RE: Request for Proposals (RFP) – Tukwila Remodel

ADDENDUM NO. 1
January 20, 2026

ADDENDUM NO. 1

QUESTIONS AND ANSWERS

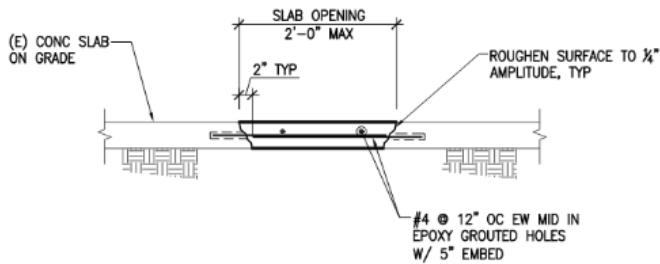
76. Q. Consumption Charges (Sheet E0.02): Electrical General Note 2 requires the Contractor to "provide temporary construction power." Please clarify if the Contractor may utilize the existing building's electrical and water services. If so, will the Owner be responsible for the monthly consumption charges during the TI renovation?
 A. Owner will cover.
